Subject: Duke Energy Carolinas, LLC
William States Lee III Nuclear Station - Docket Nos. 52-018 and 52-019
AP1000 Combined License Application for the
William States Lee III Nuclear Station Units 1 and 2
Response to Request for Additional Information
Ltr# WLG2010.07-08

Reference: Letter from Sarah Lopas (NRC) to Bryan Dolan (Duke Energy), Request for
Additional Information Regarding the Supplement to the Environmental Report
for the William States Lee III Nuclear Station, Units 1 and 2, Combined License
Application, dated June 22, 2010 (ML101370398)

Lee Nuclear Station Response to Request for Additional Information (RAI)

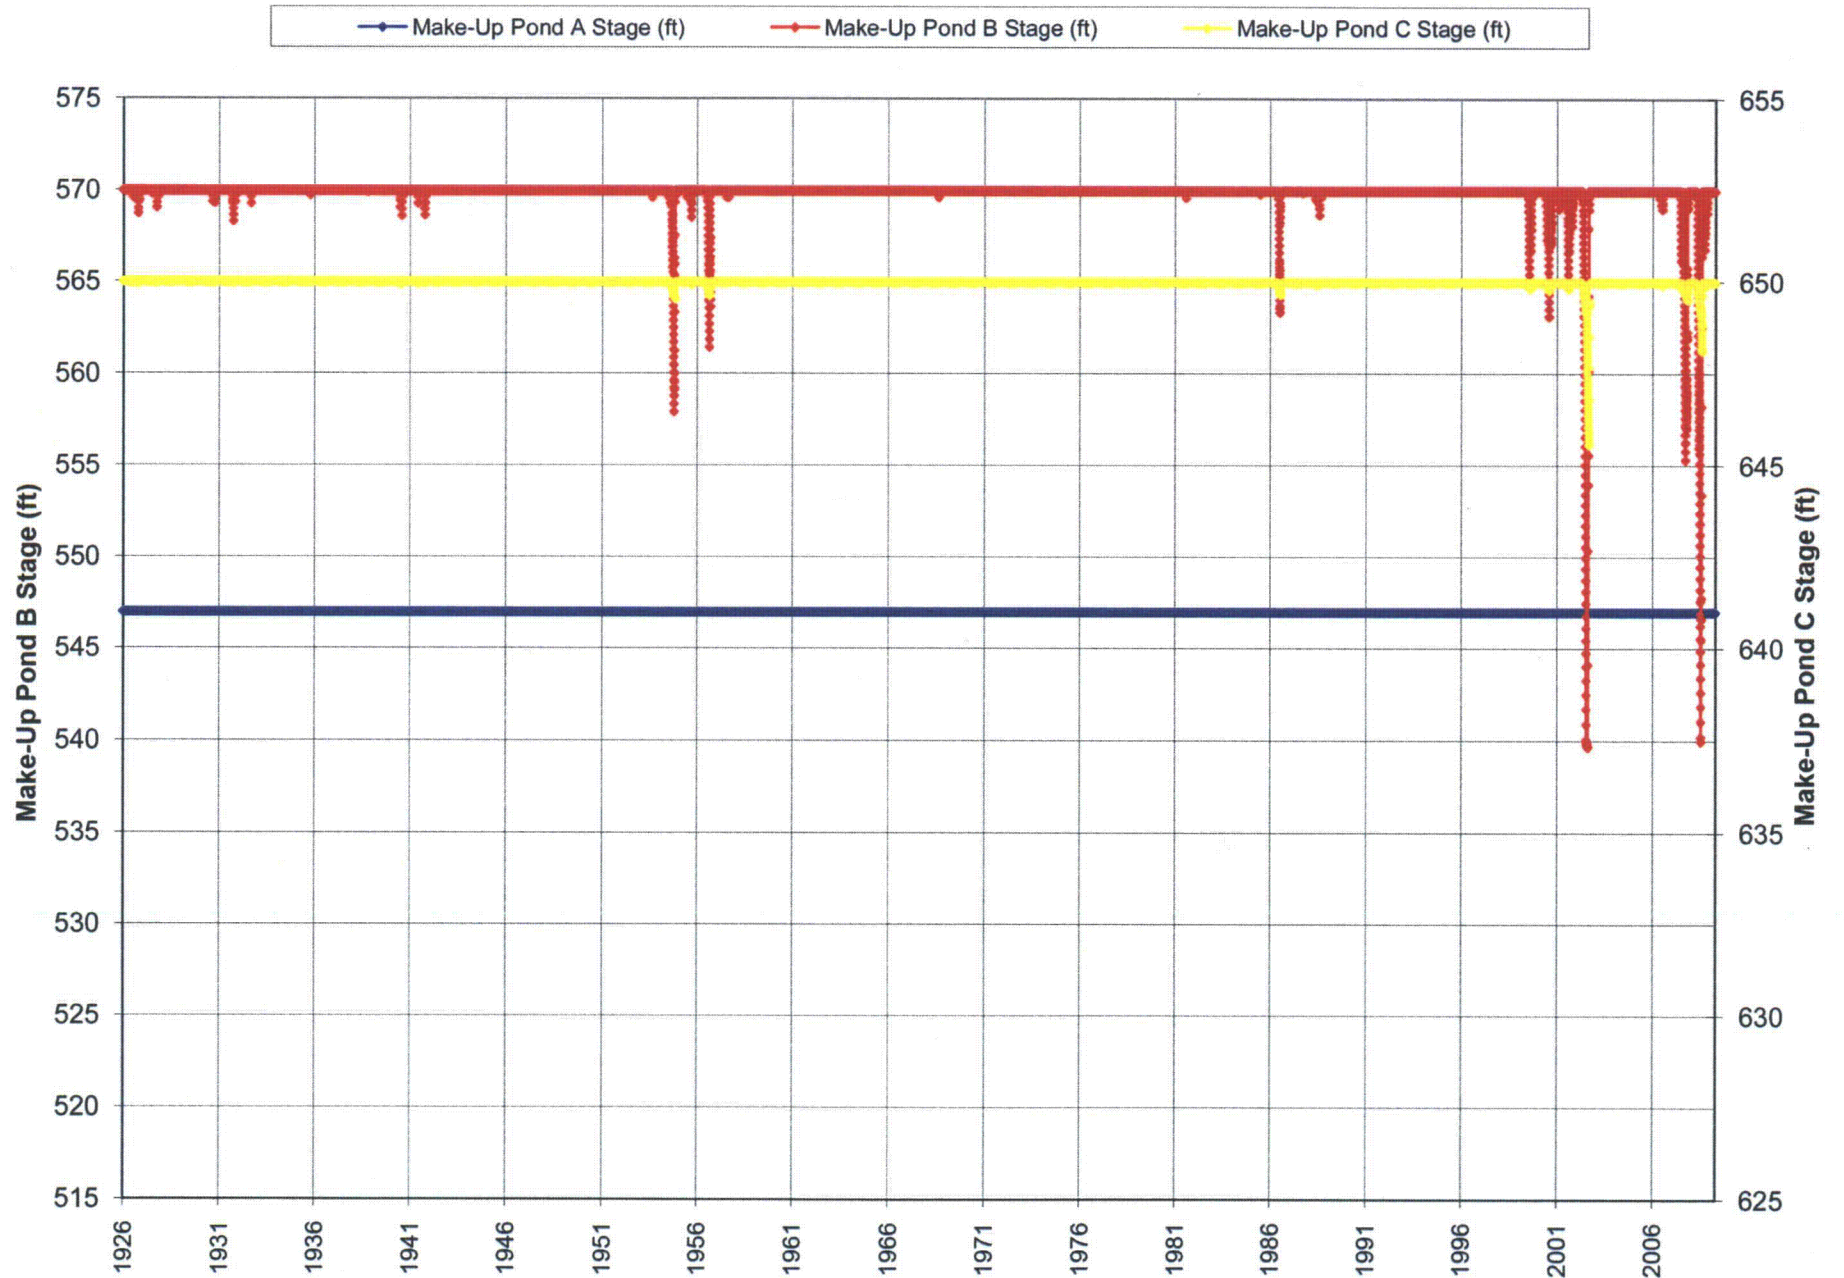
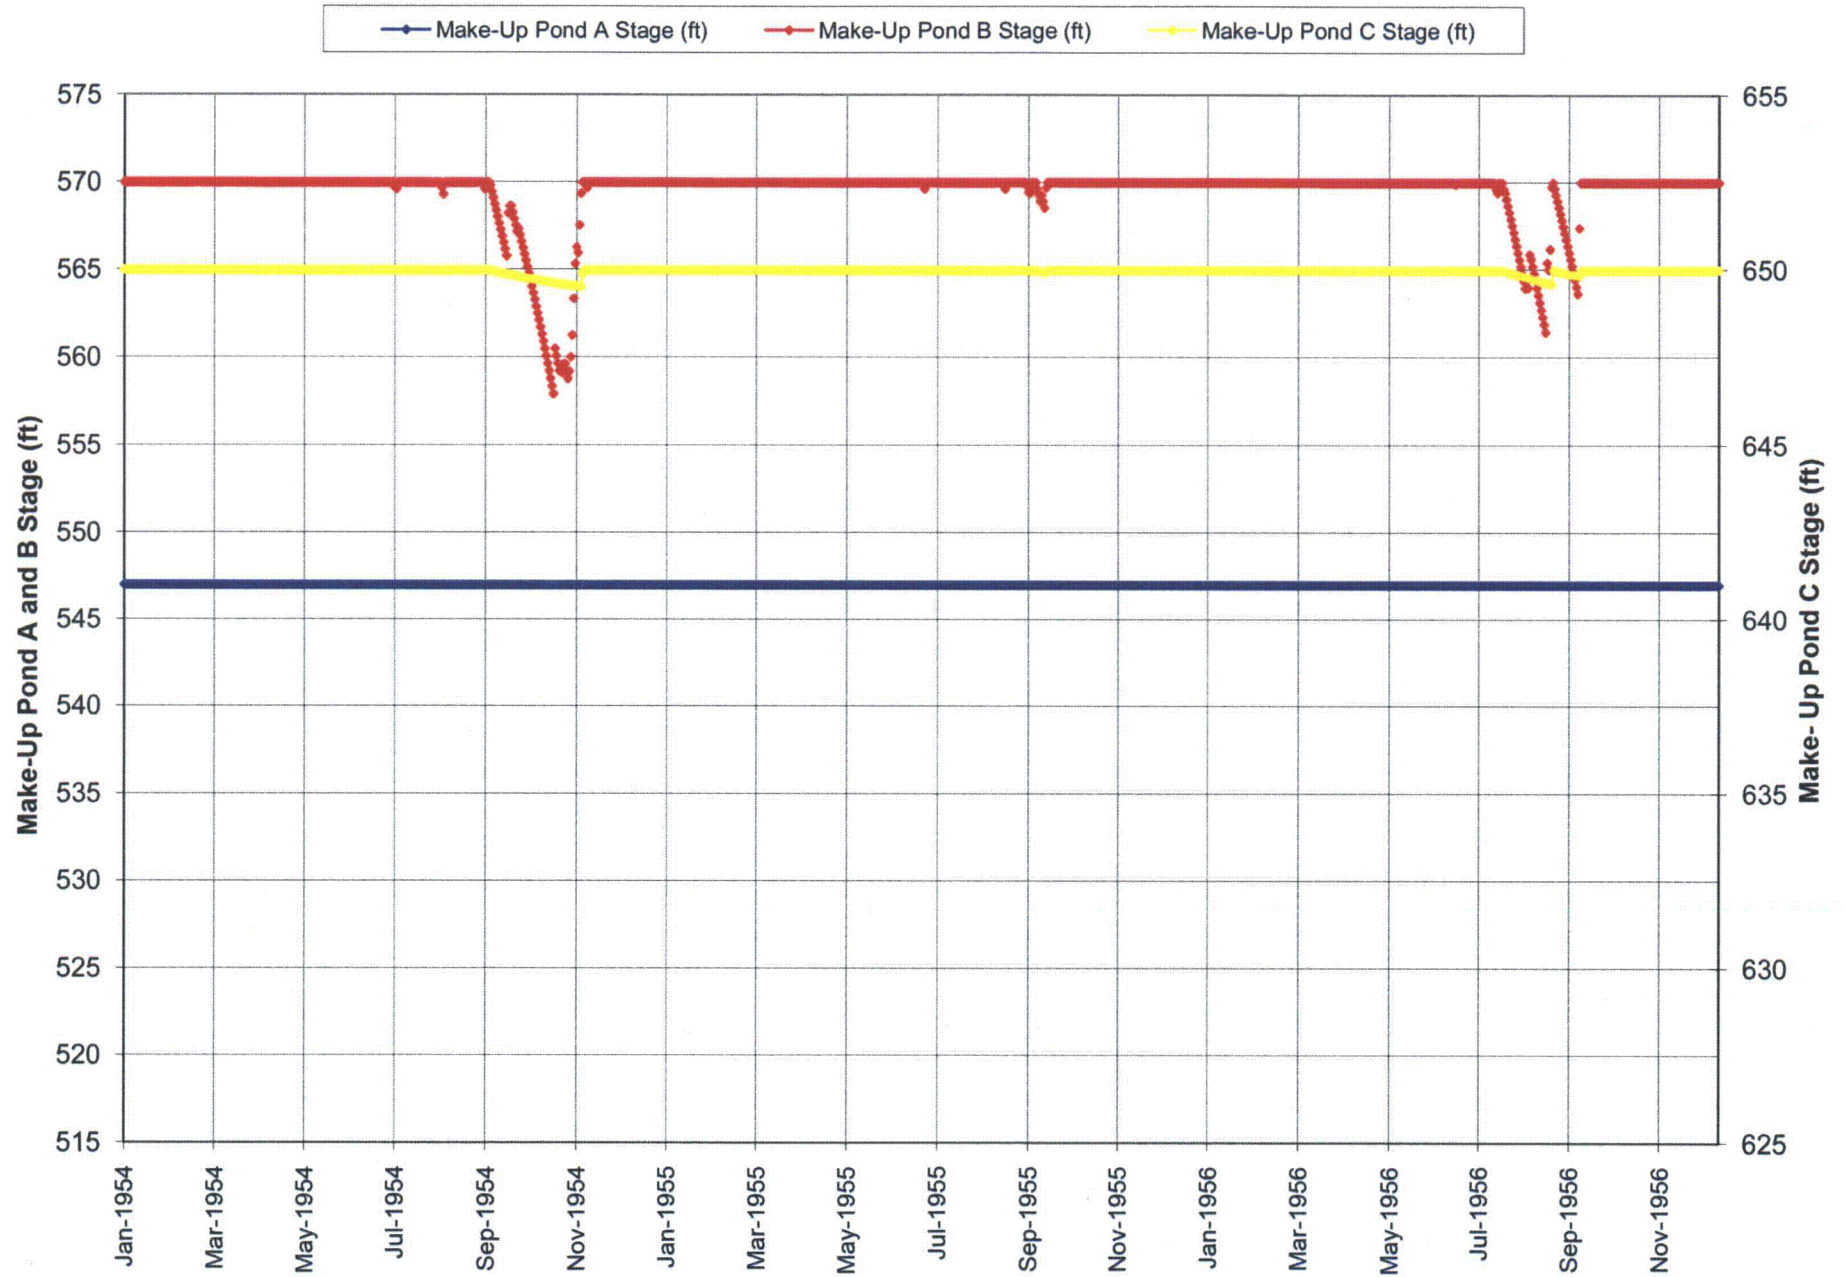
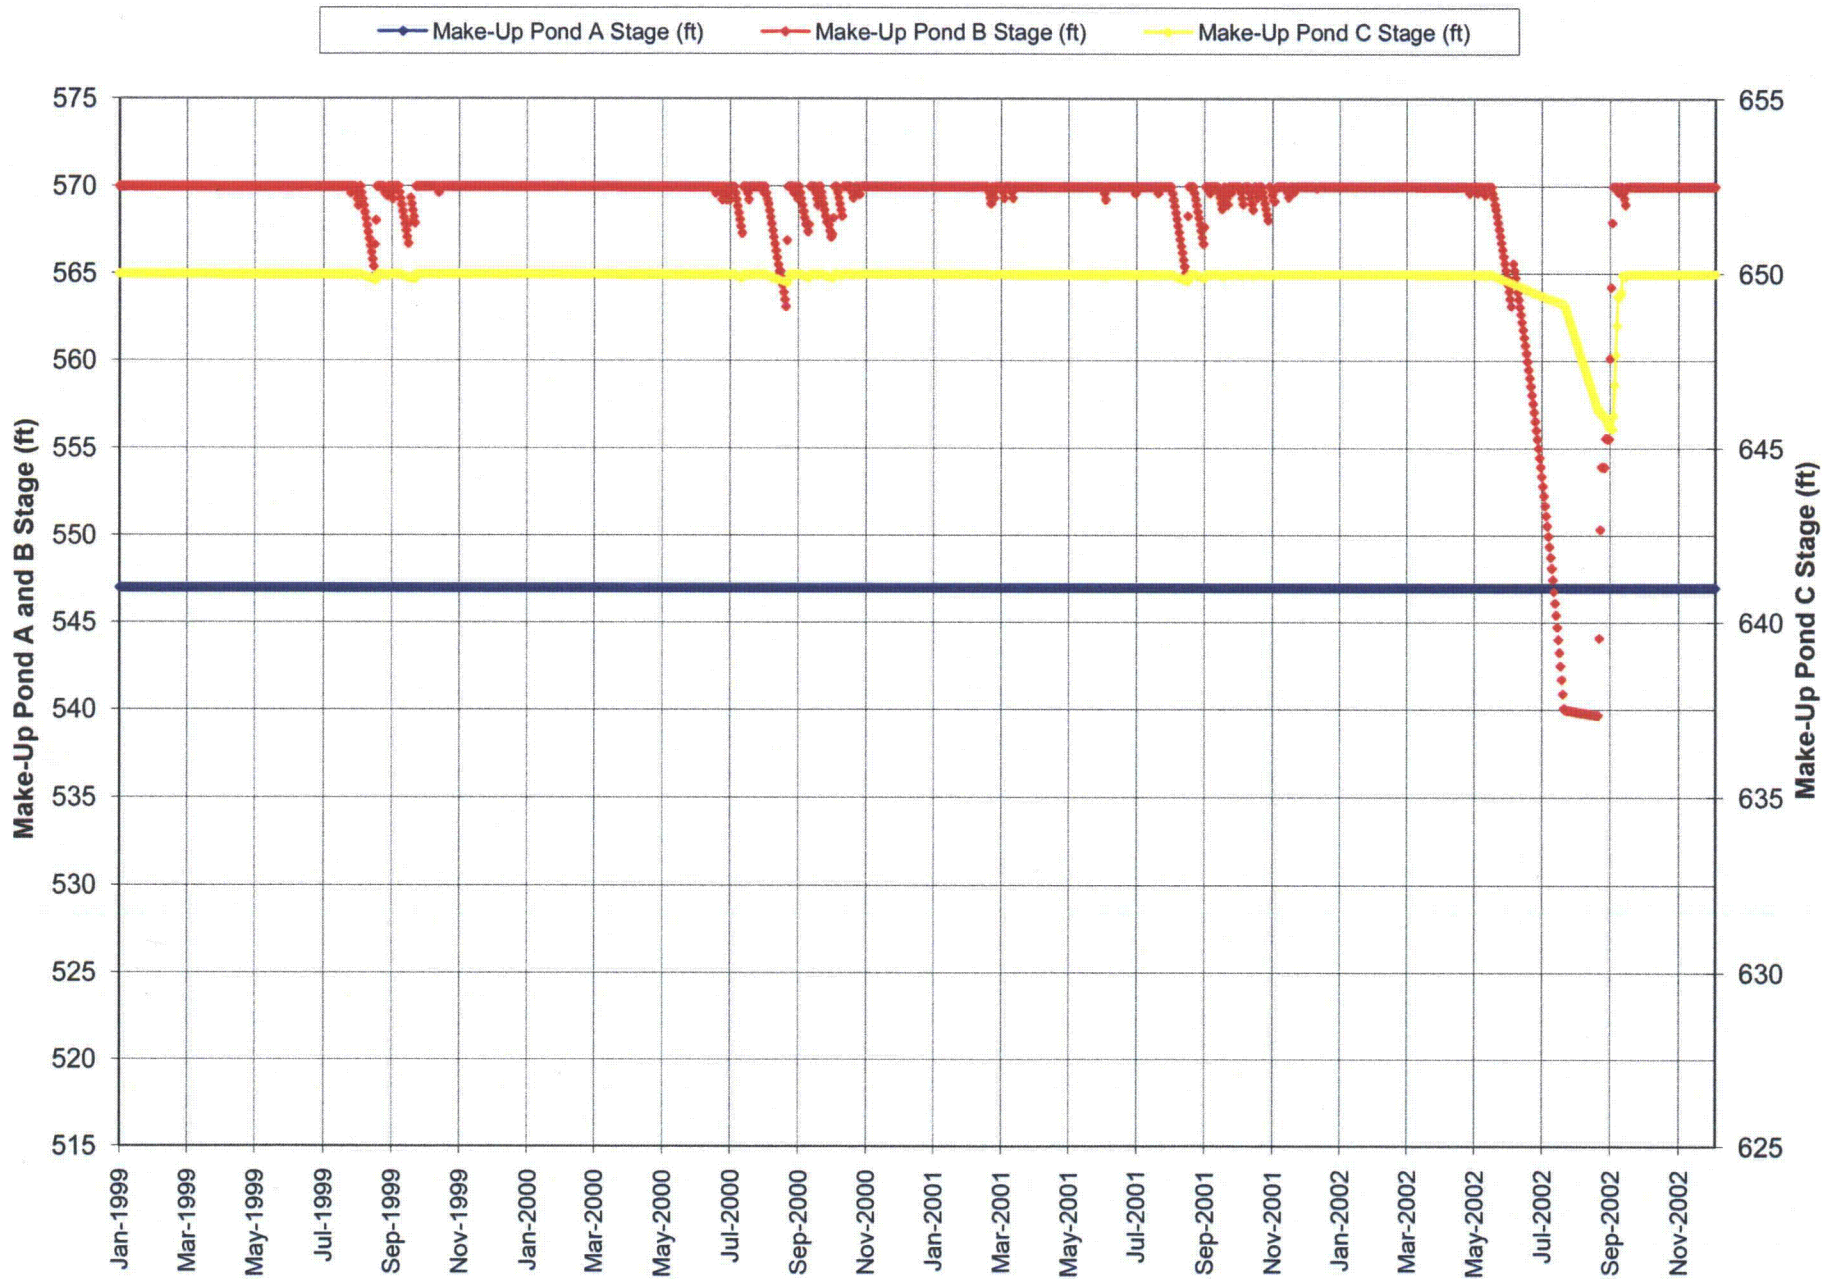
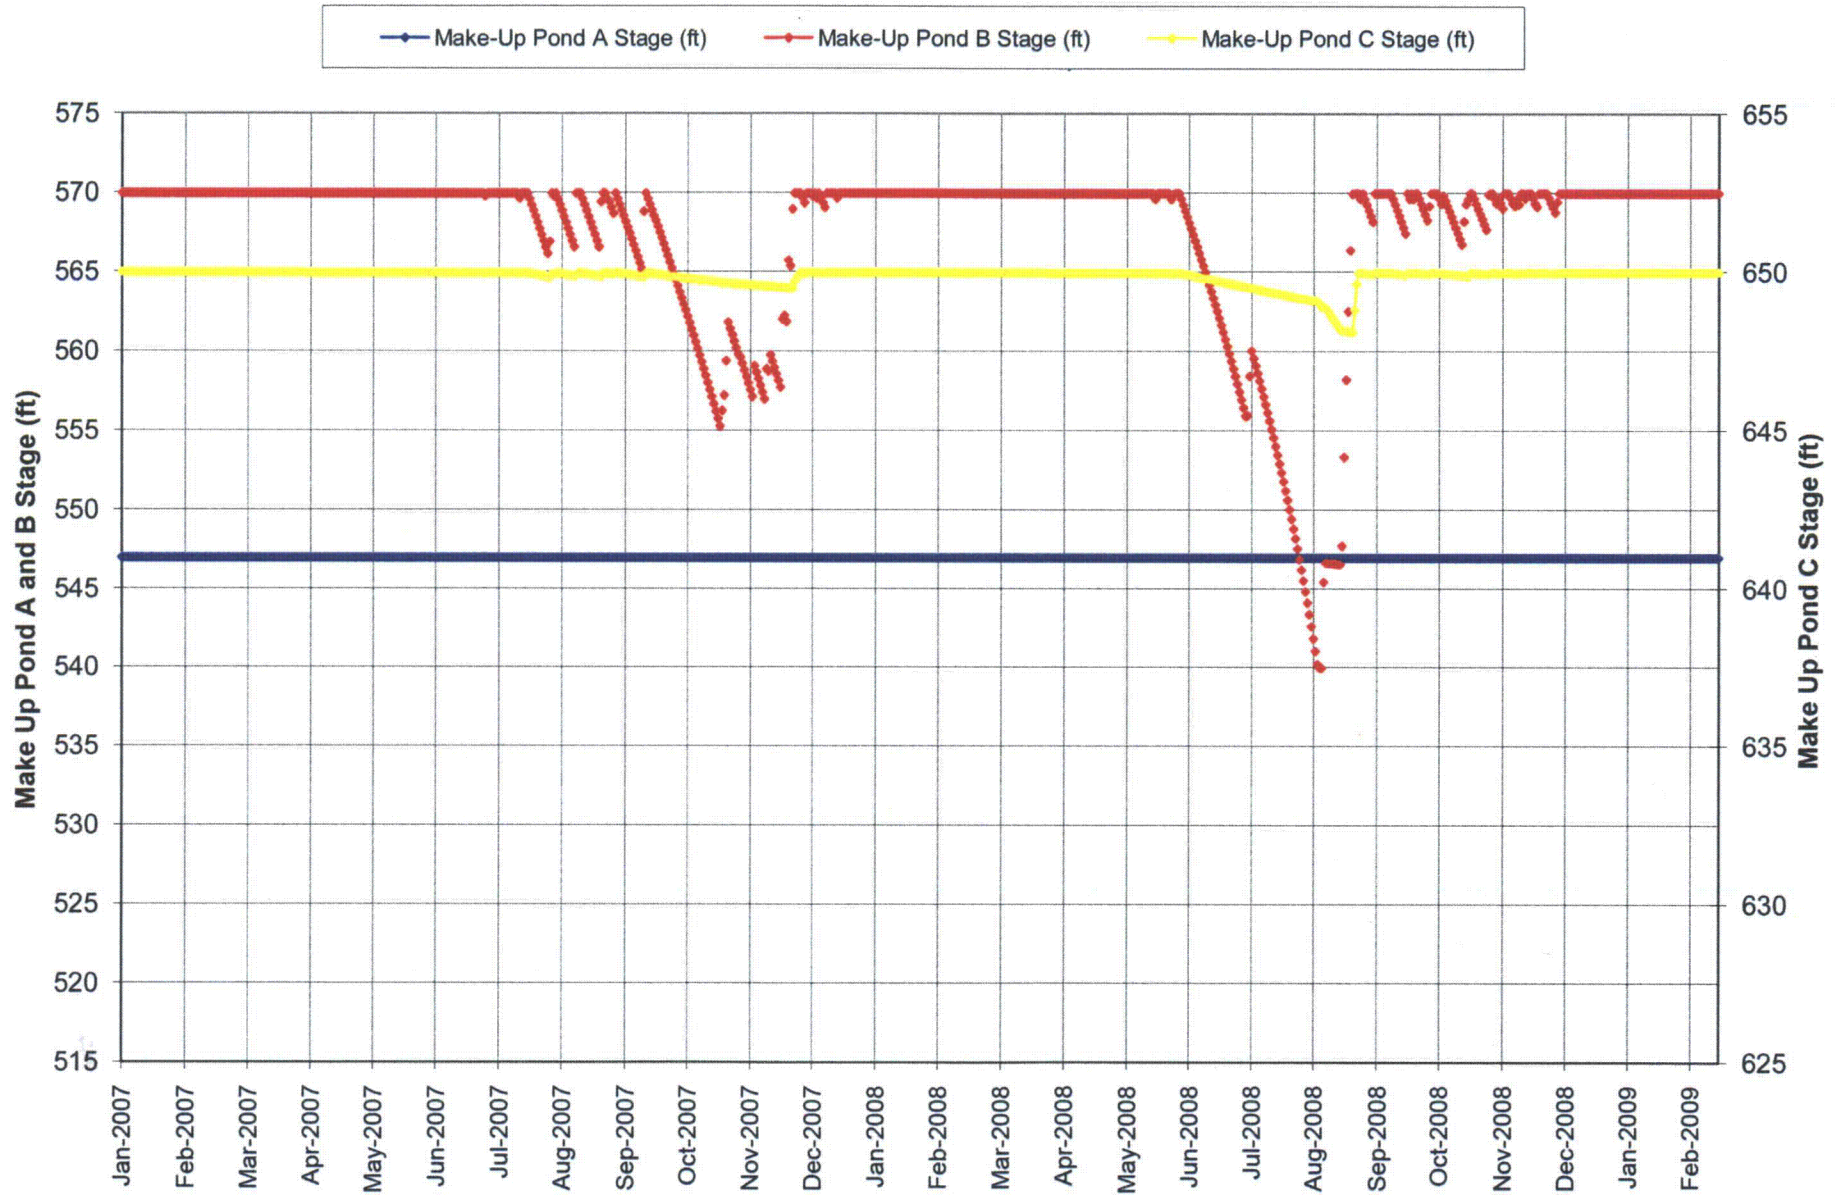
Provide additional details for the Alternative Energy analysis at the Lee Nuclear Station regarding consumptive make-up water requirements for a combined cycle natural gas-fired power plant. Specifically, provide analysis to describe whether Pond C would be required for this alternative.

The results of the water balance model run using the monthly average consumptive water use for a similar-sized combined cycle unit(s) are provided graphically in Figures 1 through 4. Figure 1 shows drawdowns in Make-Up Pond B and Make-Up Pond C for the simulated 83-year period of record. Figures 2, 3, and 4 show periods of significant drawdown from 1954 through 1956, 1999 through 2002, and 2007 through 2008, respectively.

The results of this evaluation demonstrate that Make-Up Pond C would be needed to provide make-up water for a combined cycle natural gas-fired power plant located on the site of the proposed Lee Nuclear Station. The use of Make-Up Pond C would have been needed for 37 days in 2002 and 9 days in 2008.
